Technical BULLETIN

CERTAIN 2006 ~ 2019 FJR13AC/AEC/ASC/PC (CALIFORNIA MODELS) Canister Replacement/ Air Vent Hose Relocation Due to Water Intrusion

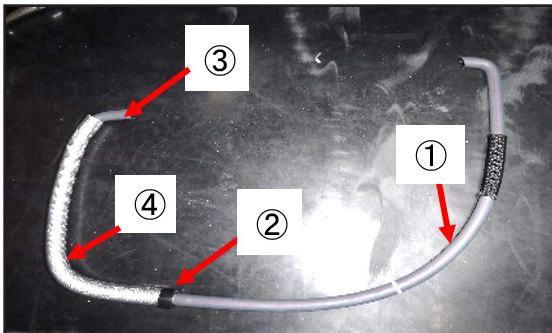
1. Remove the canister by loosening the bolts while supporting the canister with your hand to prevent bending or damaging the mounting bracket.
2. Disconnect the hoses from the canister. Discard the old canister and air vent hose.

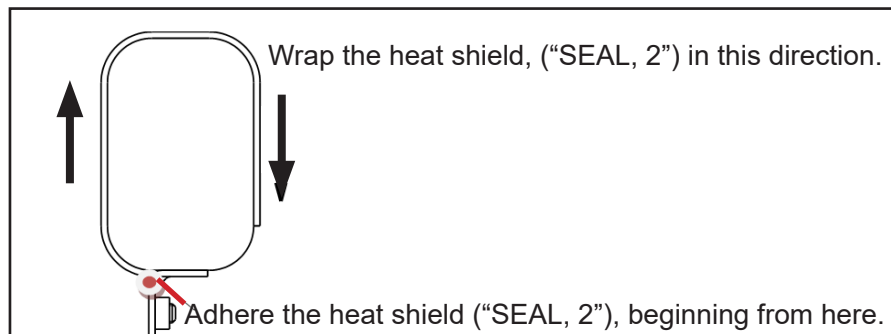
3. Assemble the parts from the kit as shown below by sliding the "PROTECTOR, PIPE" over "PIPE, 4" and connecting "PIPE, 5" using the "JOINT."

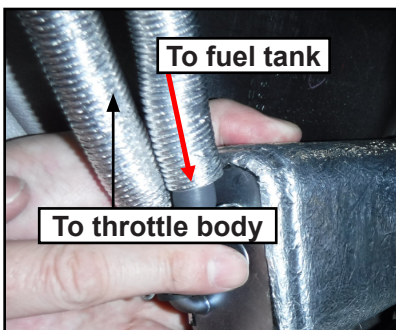
4. Adhere "SEAL2" (heat shield) to the new "CANISTER" as shown below.

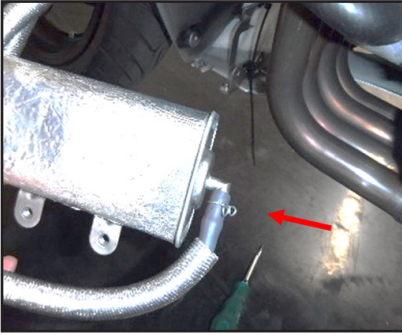
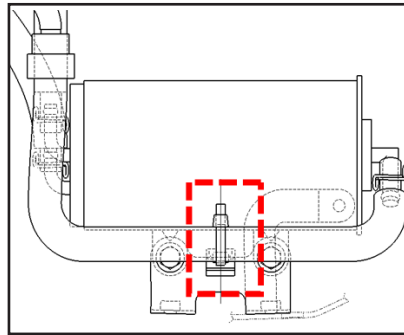
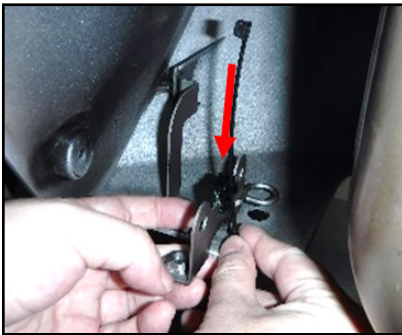
5. Connect the existing hose leading to the fuel tank to the canister as shown using new clips supplied from the kit.

6. Attach the newly assembled "PIPE, 4" from step 3 to the opposite side of the canister as shown.

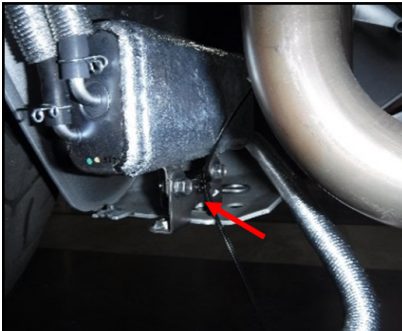
7. Put the "CLAMP" (zip tie) through the "BRACKET, CANISTER" as shown.

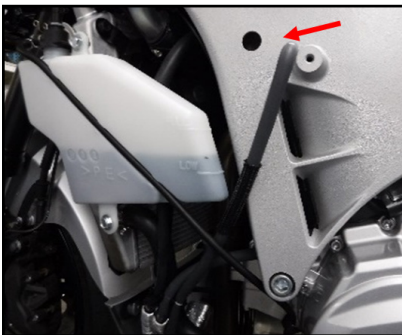
8. Install the "CANISTER" on the "BRACKET, CANISTER."

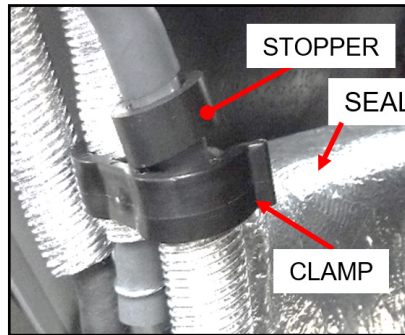
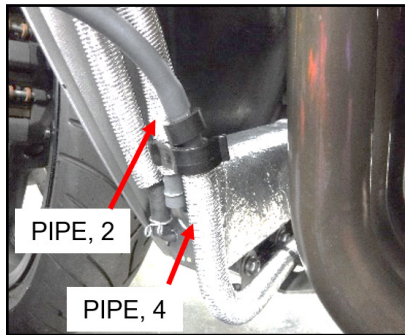
9. Insert the "GROMMET" into the existing hole of the frame as shown.

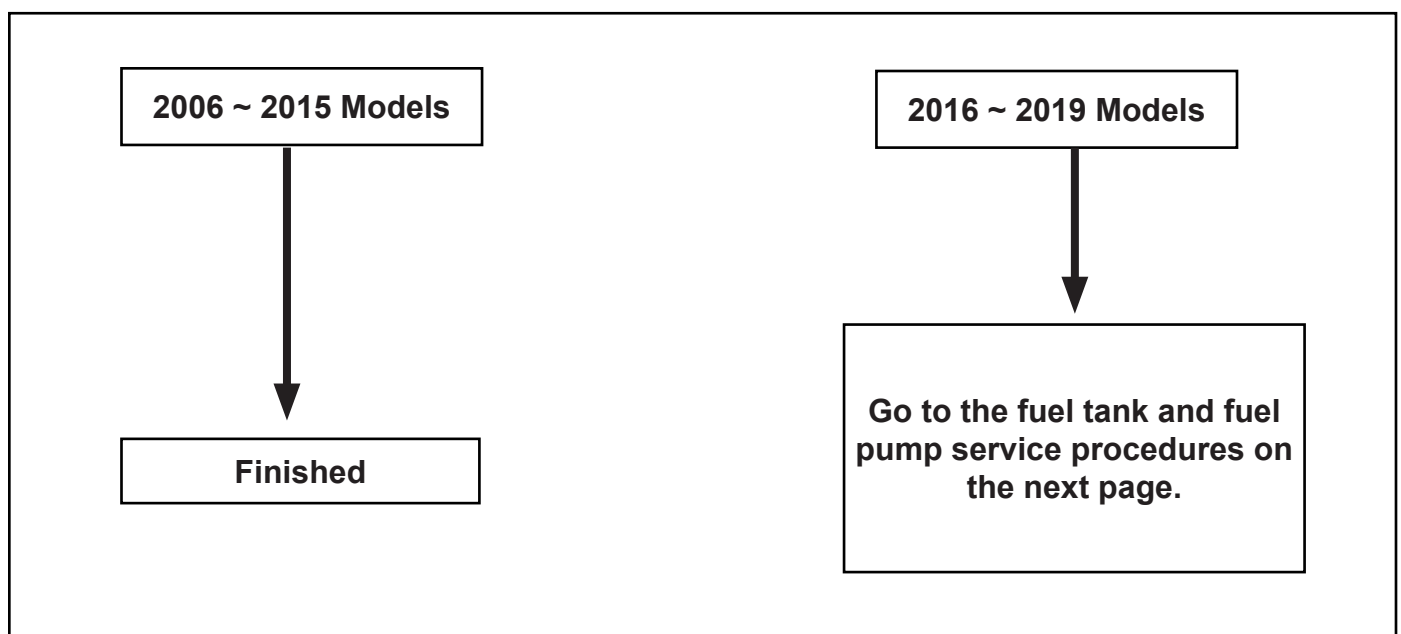
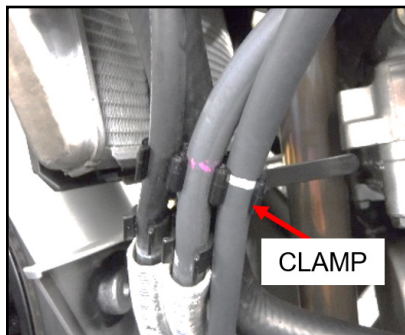
10. Install the clamp to secure "PIPE, 2" and "PIPE, 4" as shown.

11. Clamp "PIPE, 2" and "PIPE, 5" together as shown.

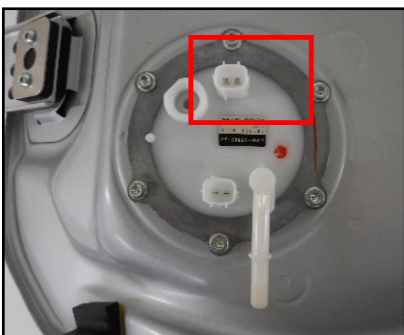
2. Drain the fuel from the tank into an appropriate clean container for re-use and remove the fuel pump from the fuel tank.
3. Test the resistance of the fuel pump's sending unit from the terminals shown below for steps 4 and 5.

4. Measure the resistance of the sending unit's with the float in the low position.

5. Measure the sending unit's resistance with the float in the upper position.

Reference value: $140 \pm 1 \Omega$

Reference value: $20 \pm 1 \Omega$
